CITY OF SOMERVILLE, MASSACHUSETTS
MAYOR'S OFFICE OF STRATEGIC PLANNING & COMMUNITY DEVELOPMENT
JOSEPH A. CURTATONE
MAYOR

Case #: PB 2014-01
Site: 181 & 197 Washington Street
Date of Decision: March 6, 2014
Decision: Petition Approved with Conditions
Date Filed with City Clerk: March 12, 2014

PLANNING BOARD DECISION

Figure A. Vertical Articulation

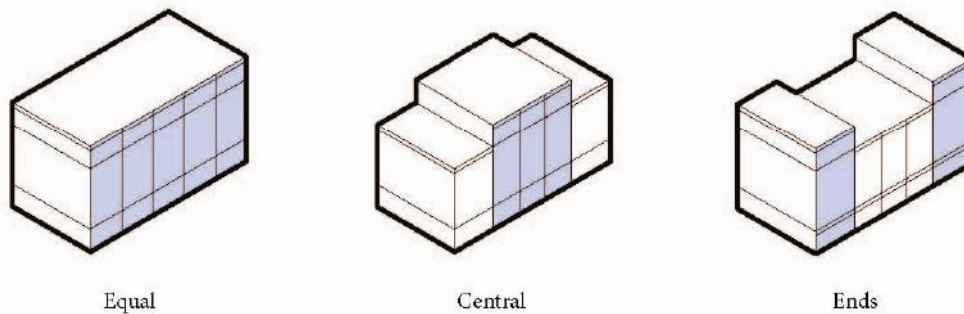
- i. The building will fill in approximately 265' of streetwall along Washington Street.
- ii. The massing and the height of the building are articulated in a manner that is compatible with the physical character of the mixed use buildings in the surrounding area. A rhythm to the building is established with a base, middle and top, with cornice lines and vertical accents to break up the building's massing. The Applicant has started an 'ends' approach (see below), similar to the guidelines of the recently approved Northpoint Zoning District. A condition of this report is that the Applicant complete this design element on the east end of the SCC building. Revised elevations shall be submitted for Planning Staff review and approval.
